EEG-56
DOE/AL/58309-56
Original Contract DE-AC04-79AL10752

**Unresolved Issues for the Disposal of Remote-Handled Transuranic Waste
in the Waste Isolation Pilot Plant**

Matthew K. Silva and Robert H. Neill

September 1994

Fig. 1. Estimated RH TRU inventory for emplacement in WIPP. Estimates based on U.S. DOE Integrated Data Base (U.S. DOE, 1986, 1987, 1988c, 1989, 1990d, 1991d, 1992) except where noted.

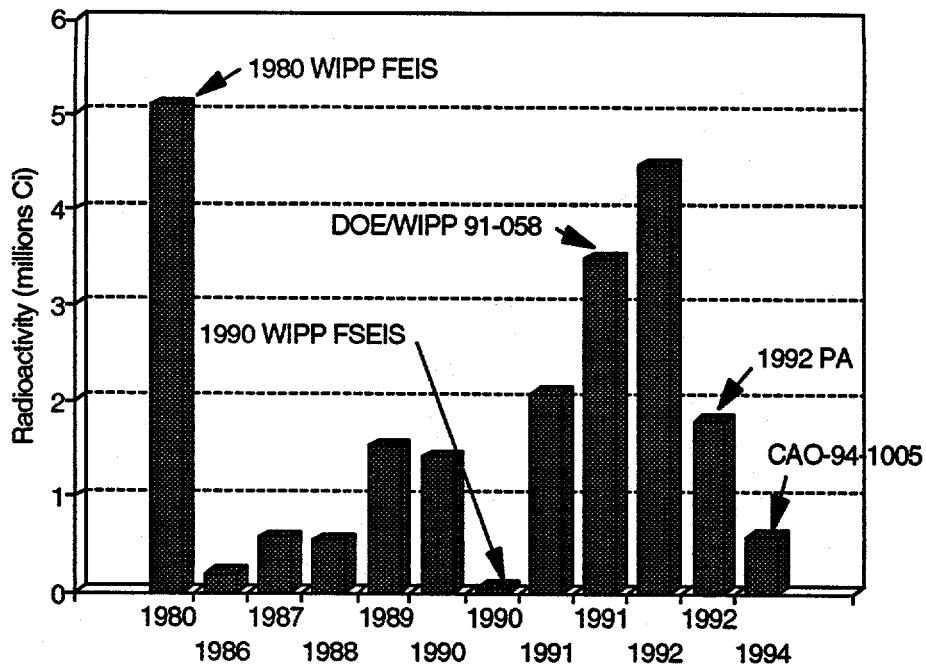
However, the RH TRU inventory has changed considerably in the last several years (Sandia, 1992, vol 3, sec. 3.4.2). Figure 1 shows the disparity in the various estimates by the DOE of the radioactivity of the RH TRU radionuclide inventory intended for emplacement in the WIPP.
